**Development Permit Panel
Electronic Meeting**

1. DEVELOPMENT PERMIT DP 23-020753
(REDMS No. 8515725)

APPLICANT: Polygon Talistar Homes Ltd.

PROPERTY LOCATION: 3420 Ketcheson Court

Changes to the building exterior:

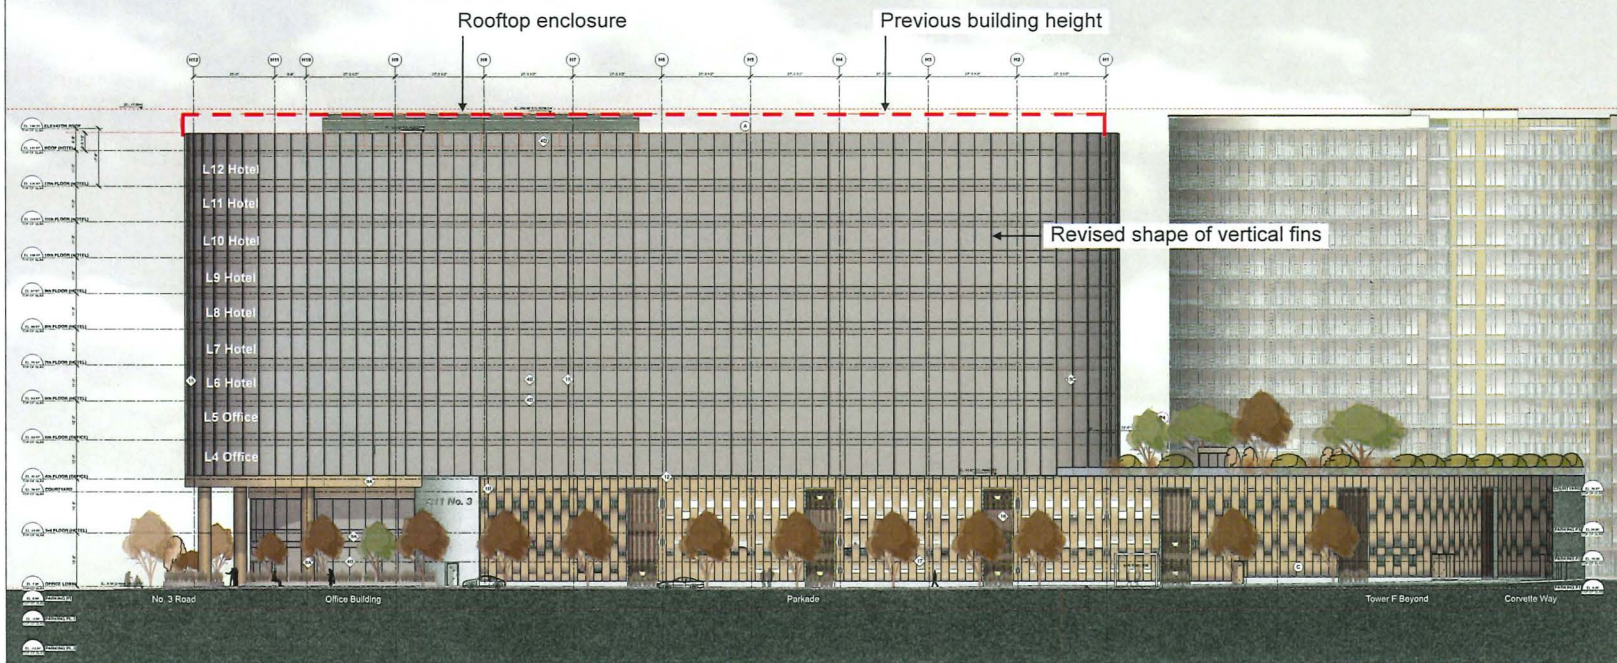
In reply to queries from Panel regarding the exterior elevation changes to the office and hotel tower, the applicant noted that (i) the concrete core for the office and hotel has been relocated to the middle of the building and replaced with punched windows, (ii) the undulating glass fins have been replaced with a beauty cap for the triple glazed curtain wall, (iii) minor changes to the fenestration to the parkade due to enlargement of the BC Hydro equipment enclosure, and (iv) the building height has lowered from floors six to twelve resulting in the relocation of the mechanical equipment that will be concealed in a setback rooftop enclosure.

- Lower floor-to-floor height for the hotel levels enabled us to lower the overall roof height.
- Added recessed rooftop enclosure.
- Minor revisions to facade openings.
- Revised shape of vertical fins from tapered to straight.

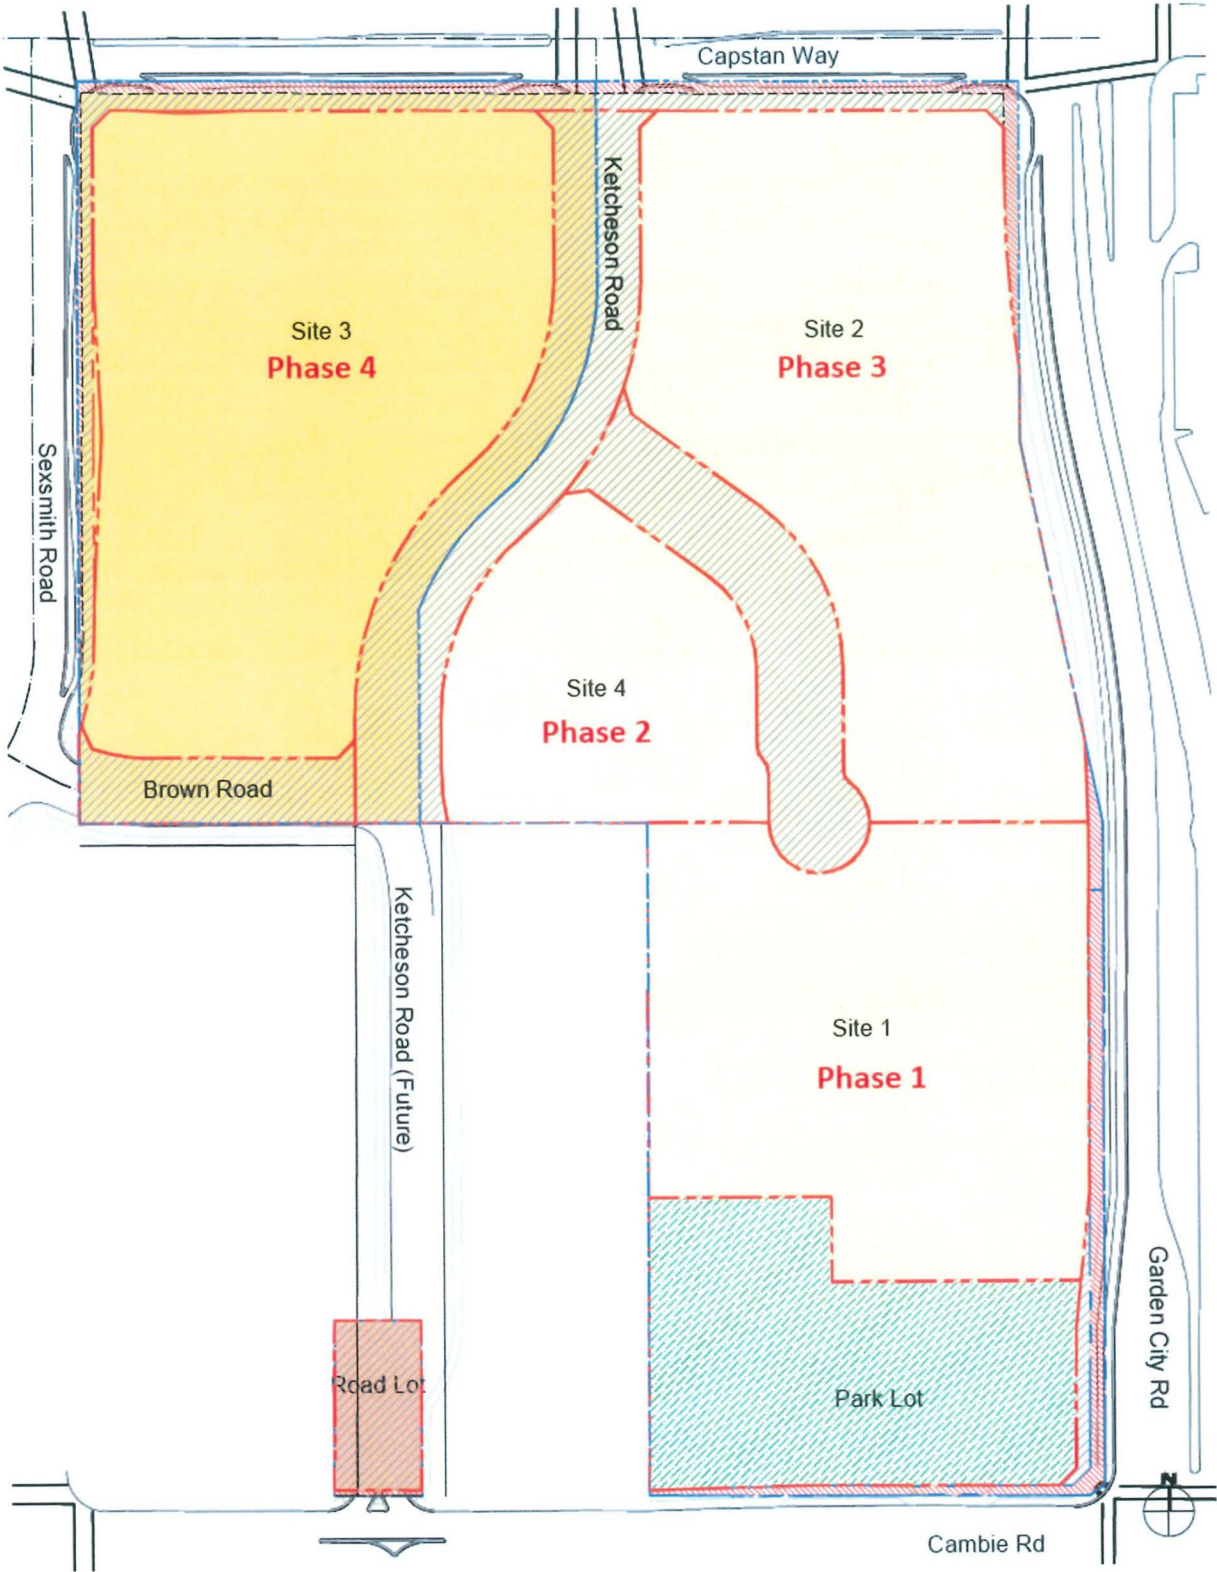
- the design of the signage for the CRUs and throughout the project should be inviting as the site is located in the Richmond Arts District; and

Signage locations are indicated on the north elevation. The tenants will have to comply with the City of Richmond signage bylaw when they make their application.
